**WATTS BAR NUCLEAR PLANT (WBN) UNIT 1 - TECHNICAL
SPECIFICATION (TS) CHANGE NO. WBN-TS-01-12 - REACTOR COOLANT
SYSTEM (RCS) SPECIFIC ACTIVITY**

PROPOSED TECHNICAL SPECIFICATION (TS) CHANGE WBN-TS-01-12
DESCRIPTION AND EVALUATION OF THE PROPOSED CHANGE

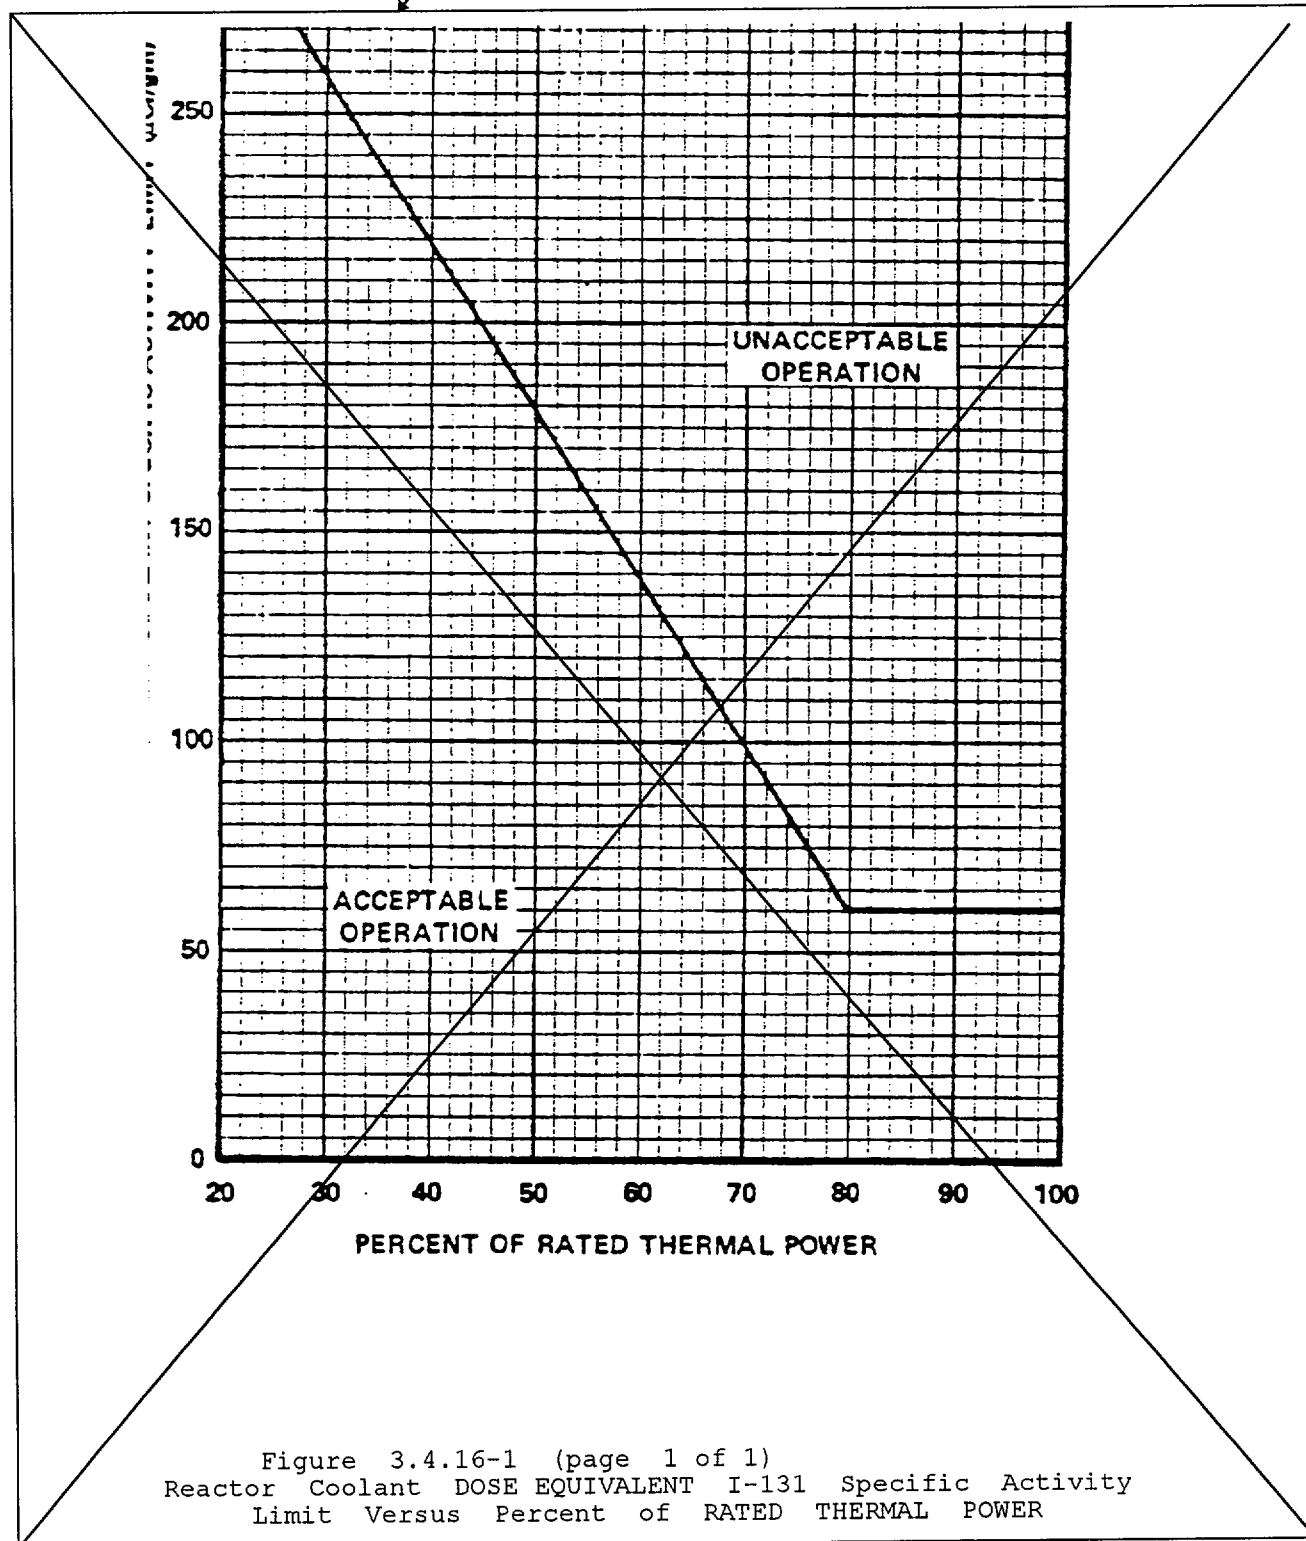
DELETE GRAPH

CONDITION	REQUIRED ACTION	COMPLETION TIME
<p>C. Required Action and associated Completion Time of Condition A not met.</p> <p>OR</p> <p>DOSE EQUIVALENT I-131 in the unacceptable region of Figure 3.4.16-1.</p>	<p>C.1 Be in MODE 3 with $T_{avg} < 500^{\circ}\text{F}$.</p> <div>REPLACE WITH: > 21 $\mu\text{Ci/gm}$</div>	6 hours
